Access Compliance Report

Public Rights-of-Way

Intersection ID: 54413	Main Street: ARDREY_KELL_RD	Cross Street: LISMORE_LN	Location: S
ADA ID: 6DB8A64BB1C1	Ramp Type: Perp	Initial Pass/Fail: Fail	Overall Compliance: No
Severity Score: 1.25			
Codes/Mitigation Info/Possible Solution		Field Measurements/Component Compliance

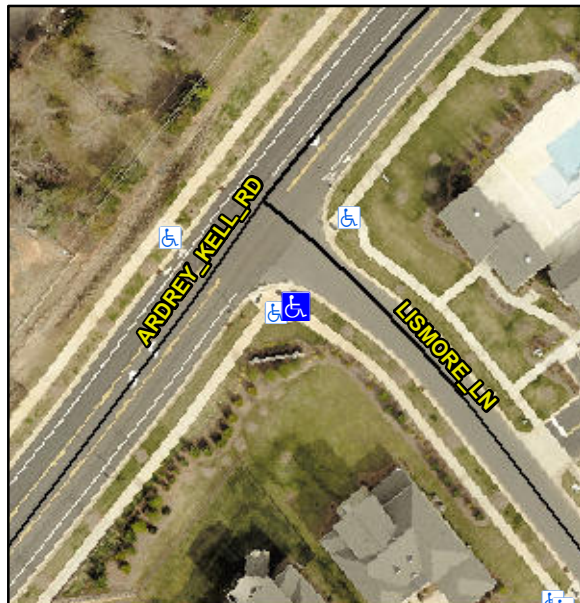
Not Found, R304.5.3

Compliance	Description	Data	Compliance	Description	Data
N/A	Ramp Length (in)	97.0	Yes	Ramp Slope (%)	7.2
Yes	Ramp Width (in)	60.0	No	Ramp XSlope (%)	4.0
N/A	Flare Type LT	N/A	N/A	Flare Type RT	N/A
N/A	Flare Slope LT (%)	N/A	N/A	Flare Slope RT (%)	N/A
N/A	Flare Traversable LT?	N/A	N/A	Flare Traversable RT?	N/A
N/A	Landing Length (in)	N/A	N/A	DWS Provided?	N/A
N/A	Landing Width (in)	N/A	N/A	DWS Contrast?	N/A
N/A	Landing Slope (%)	N/A	N/A	DWS Length (in)	N/A
N/A	Landing X Slope (%)	N/A	N/A	DWS Full Width?	N/A
N/A	Landing Curb? (Y/N)	N/A	N/A	DWS Offset (in)	N/A
N/A	Shared Landing?	N/A			
N/A	Gutter Ponding?	N/A	N/A	Gutter Slope (%)	N/A
N/A	Gutter Lip Ht (in)	2.0	N/A	Gutter X Slope (%)	N/A
N/A	Painted X Walk1?	No	N/A	Painted X Walk2?	N/A
	X Walk 1 Direction	To NE		X Walk 2 Direction	N/A
N/A	X Walk 1 Width (in)	N/A	N/A	X Walk 2 Width (in)	N/A
	X Walk 1 Slope (%)	1.2		X Walk 2 Slope (%)	N/A
	X Walk 1 X Slope (%)	3.0		X Walk 2 X Slope (%)	N/A

Remove & Replace Entire Ramp.
